RESOLUTION NO. 2014-R-07

Addendum No. 2

Final Environmental Impact Report for Metro Gold Line Foothill Extension – Azusa to Montclair (SCH 2010121069)

**Evaluating Phased Construction of the Project – Azusa-Citrus Station
to Claremont Station and east of Claremont Station to Montclair
Station**

Figure 2: Proposed Project Modifications

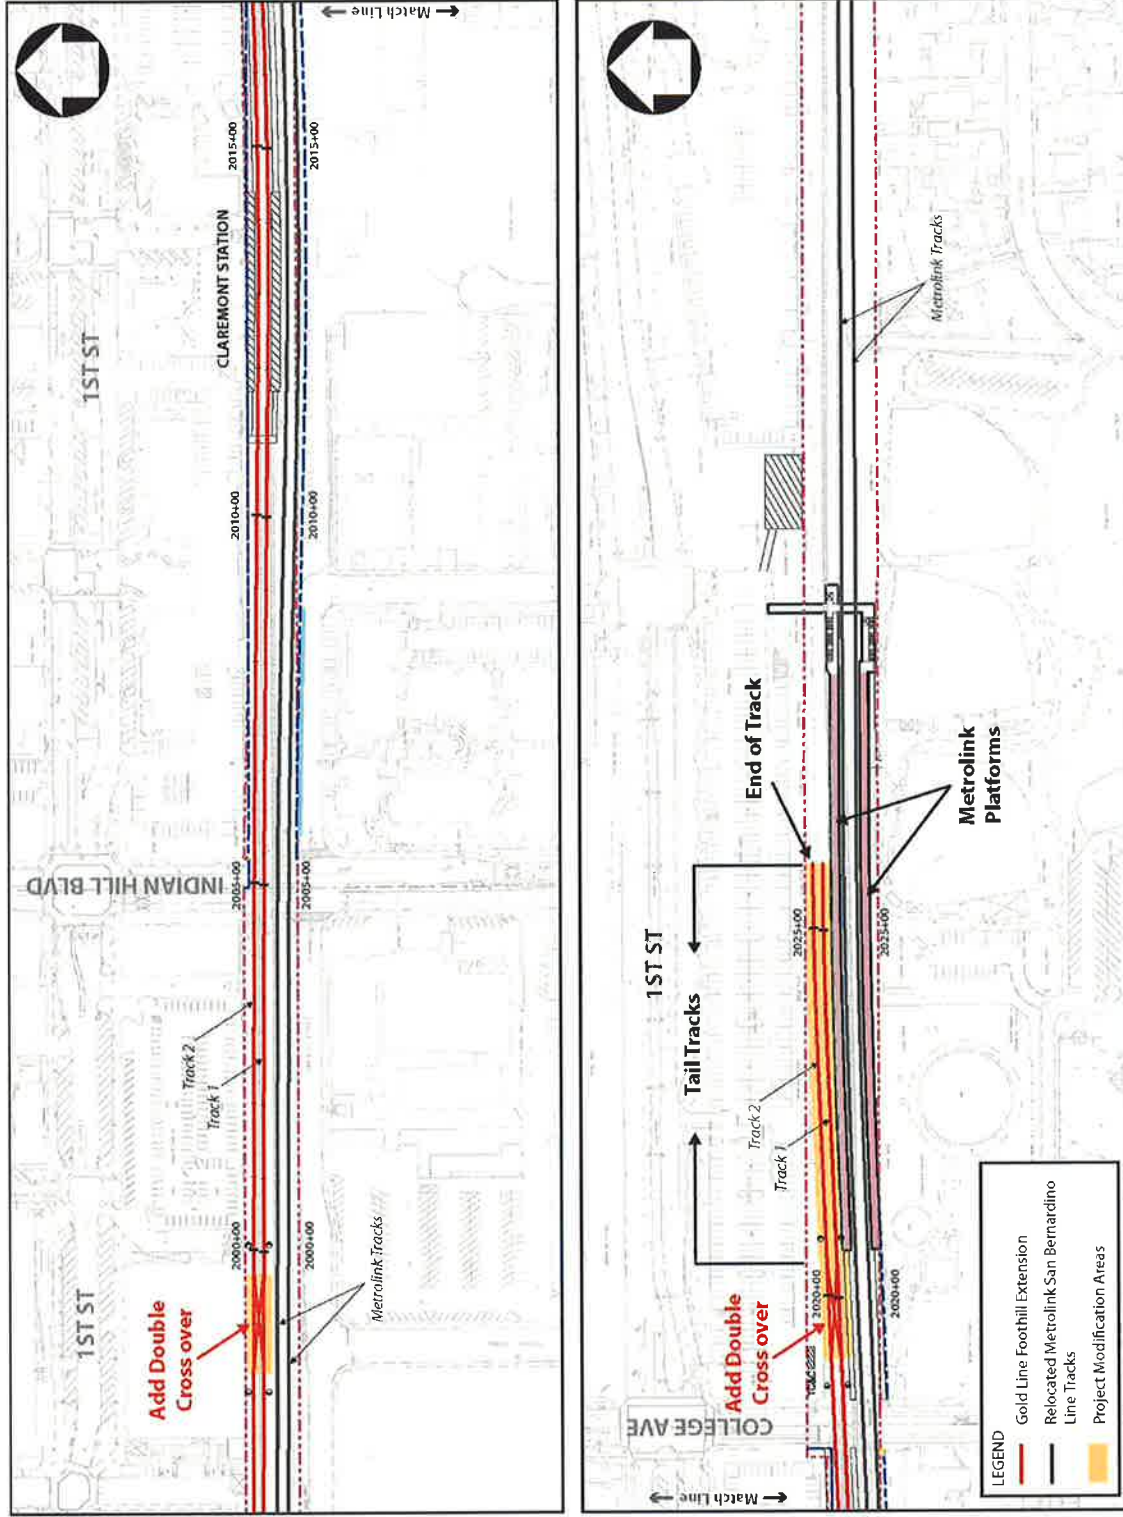
The Authority has identified minor design changes that would be necessary for specific elements of the Project in the vicinity of the Claremont Station including LRT track (track geometry and features such as track crossover locations) and provision for a LRT operator layover facility. In addition, the Authority has identified three traffic control measures to be included in the project to reduce significant impacts below the level of significance at three intersections in Pomona in light of Project changes and existing conditions. The specific Project changes, to support an end of line terminus at the Claremont Station include the following:

- Adding a double crossover approximately 500 feet west of the Indian Hill Boulevard grade crossing
- Adding a double crossover approximately 100 feet east of the College Avenue grade crossing

- Terminating the track approximately 450 feet east of the new crossover at College Avenue which allows for storage of 2-three car light rail trains, one on each track

- Providing an approximate 200 square foot layover facility for LRT operators to be located inside the existing Santa Fe Depot
- Modifying the Garey Avenue and Bonita Avenue intersection pursuant to one of the following alternatives, to be selected by the Authority with the concurrence of the City of Pomona upon further engineering analysis: (1) reconfiguring of (a) the northbound approach to provide two exclusive left-turn lanes, one through lane, one shared through/right-turn lane, and two (northbound and southbound) buffered bike lanes, and (b) the westbound “receiving leg” to preserve the existing bike lane and accommodate two through receiving lanes, (c) alignment of receiving lanes in all directions, and (d) pavement widening, signal and related work included as

- Modifying the Towne Avenue and Bonita Avenue intersection pursuant to one of the following alternatives, to be selected by the Authority with the concurrence of the City of Pomona upon further engineering analysis: (1) reconfiguring (a) the northbound approach to provide two exclusive left-turn lanes, one through lane, and one shared through/right-turn lane, and (b) the westbound “receiving leg” to preserve the existing bike lane and accommodate two through receiving lanes, (c) alignment of receiving lanes in all directions, and (d) pavement widening, signal and related work included as determined necessary by the City; or (2) widening the existing roadway and potentially the right-of-way of Bonita Avenue to accommodate (a) on the northbound approach two exclusive left-turn lanes, one through lane, and one shared through/right-turn lane, and (b) reconfiguring the westbound “receiving leg” to preserve the existing bike lane and accommodate two through receiving lanes, (c) alignment of receiving lanes in all directions, and (d) pavement widening, signal and related work included as determined necessary by the City.

- Installing signage prohibiting left turns from westbound Towne Center Drive to southbound Towne Avenue from 7 AM to 9 AM to reduce intersection delay and eliminate a potential significant impact.

All other features of the Approved Project in the vicinity of the Claremont Station would remain the same as described in the 2013 FEIR. Addendum No. 2 evaluates the effects of the proposed project modifications identified above. None of the proposed project modifications constitute substantial changes to the Approved Project, would result in new significant impacts, or contribute to previously identified significant effects that would be substantially more severe than shown in the 2013 FEIR. Accordingly, the Authority finds that the preparation of an Addendum pursuant to CEQA Guidelines Section 15164 is appropriate, and that the proposed changes to the Project do not trigger a requirement to prepare a supplemental or subsequent EIR. These Proposed Project changes are illustrated on Figure 2.
